PoDL SCCP

Heath Stewart

Presentation Objectives

Figure 104-X – CRC8 field generation

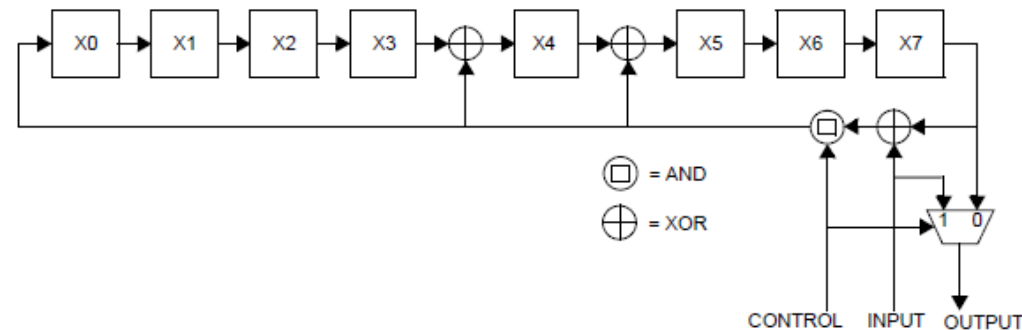
- Add 104.6.4.5 CRC8 field

The CRC8 field is an 8-bit cyclic redundancy check value. This value is computed as a function of the contents of the 16-bit Scratchpad Read payload.

The encoding is defined by the generating polynomial shown in Equation (104-X):

$$G(x) = x^8 + x^5 + x^4 + 1$$

This CRC8 calculation shall produce the same result as the serial implementation shown in Figure 104-X. Before calculation begins, the shift register shall be initialized to the value 0x00. The content of the shift register is transmitted without inversions.

Reset command timing proof

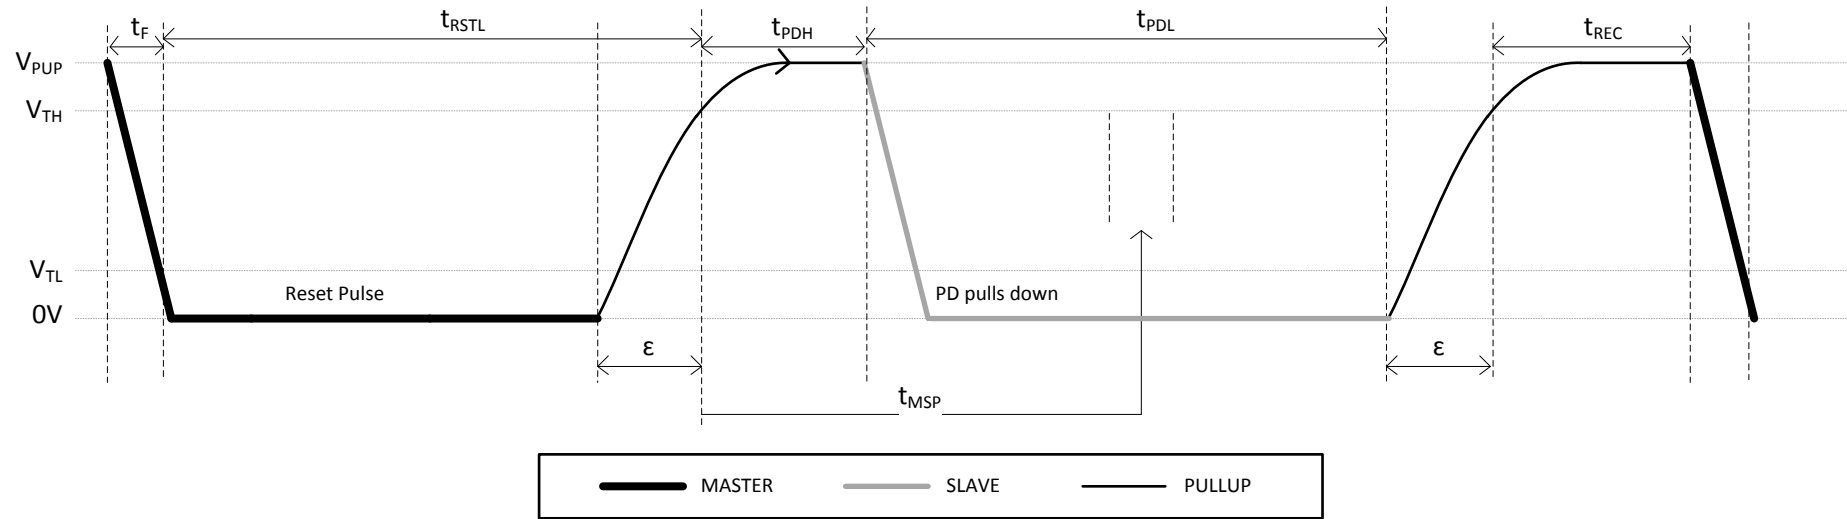
Symbol	Min	Typ	Max	Unit	Note
t_F	0		100	us	5V pu vs 100Ohm pd
ϵ			230	us	4mA PSE pu / 0.2uF C_{chan} to 4.6V
t_{RSTL}	9	10	11	ms	PSE LO time for Reset pulse
t_{PDH}	0.5	1.0	1.5	ms	PD HI, measured from rising edge V_{TH}
t_{PDL}	2.0	4.0	6.0	ms	PD LO, presence pulse, measured from rising edge V_{TH}
t_{MSP}	1.6	1.8	2.0	ms	PSE presence capture, measured from rising edge V_{TH}
t_{REC}	270	300	330	us	Must charge PD SCCP reservoir capacitor
$t_{SLOT,RST}$			18.1	ms	
t_{LO}			10	ms	PD must maintain state

Write 0/1 slot timing proof

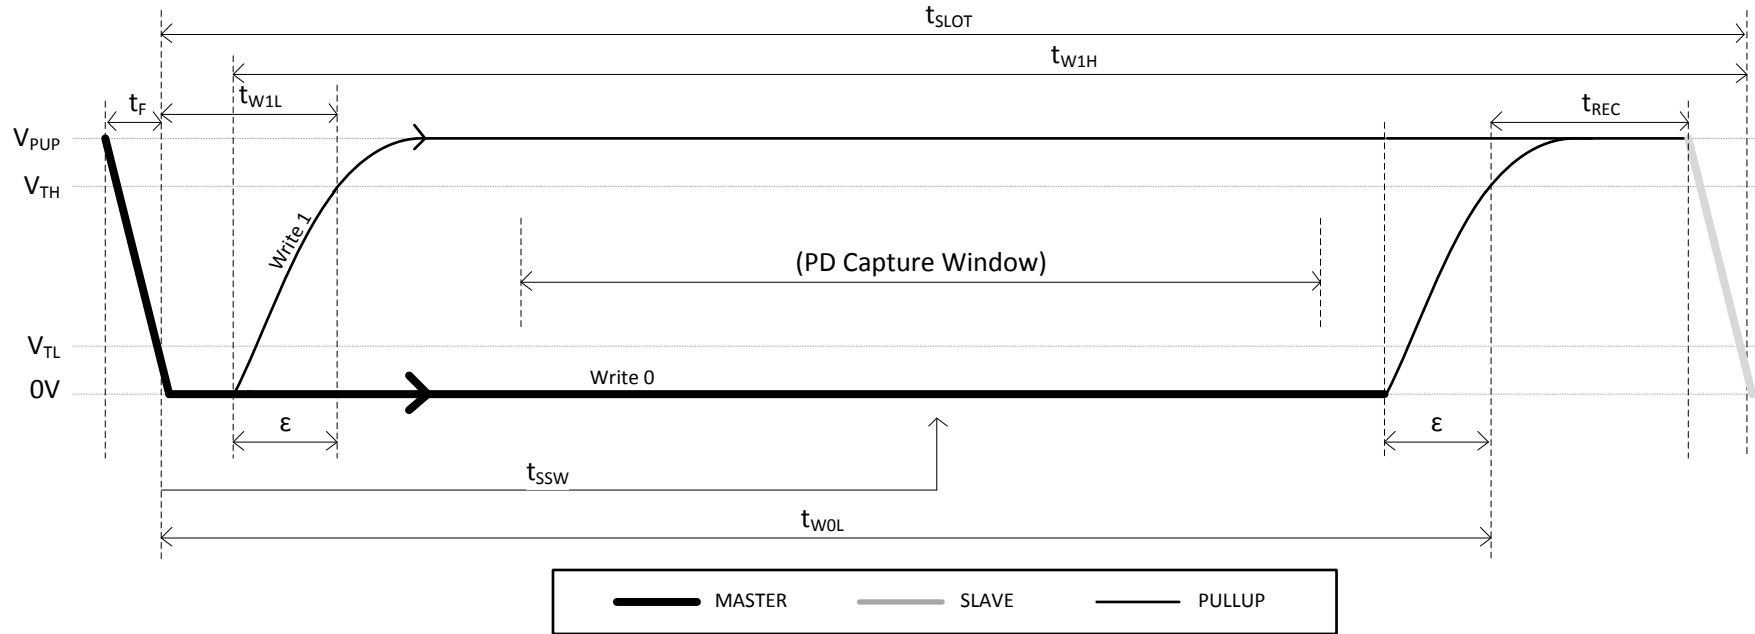
Symbol	Min	Typ	Max	Unit	Note
t_F	0		100	us	5V pu vs 100Ohm pd
ϵ			230	us	4mA PSE pu / 0.2uF C_{chan} to 4.6V
t_{W1L}	90		330	us	PSE LO time for Write 1 symbol
t_{W1H}	1.6	1.8	2.0	ms	PSE HI time for Write 1 symbol
t_{SSW}	0.5	1.0	1.5	ms	PD capture measured from falling edge V_{TL}
t_{WOL}	1.8	2.0	2.2	ms	PSE hold time for Write 0 symbol
t_{REC}	270	300	330	us	Charge PD SCCP reservoir capacitor
t_{SLOT}	2.7	3.0	3.3	us

Read 0/1 slot timing proof

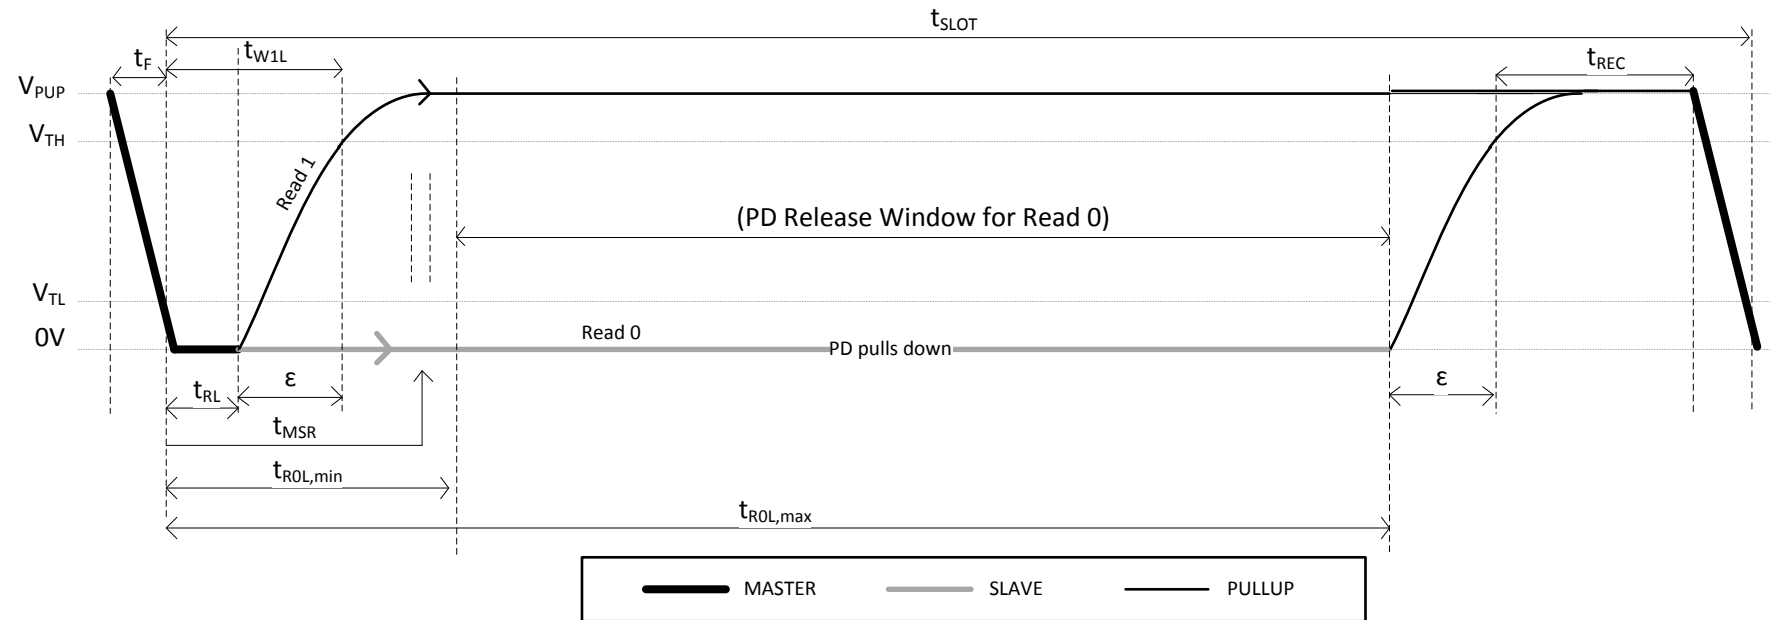
Symbol	Min	Typ	Max	Unit	Note
t_F	0		100	us	5V pu vs 100Ohm pd
ϵ			230	us	4mA PSE pu / 0.2uF C_{chan} to 4.6V
t_{W1L}	90		330	us	
t_{RL}		$T_{W1L} - \epsilon$		us	
t_{MSR}	270	300	330	us	PSE capture, from falling edge V_{TL}
t_{ROL}	0.5	1.0	1.5	ms	PD release, measured from falling edge V_{TL}
t_{REC}	270	300	330	us	Must charge PD SCCP reservoir capacitor
t_{SLOT}	2.7	3.0	3.3	us
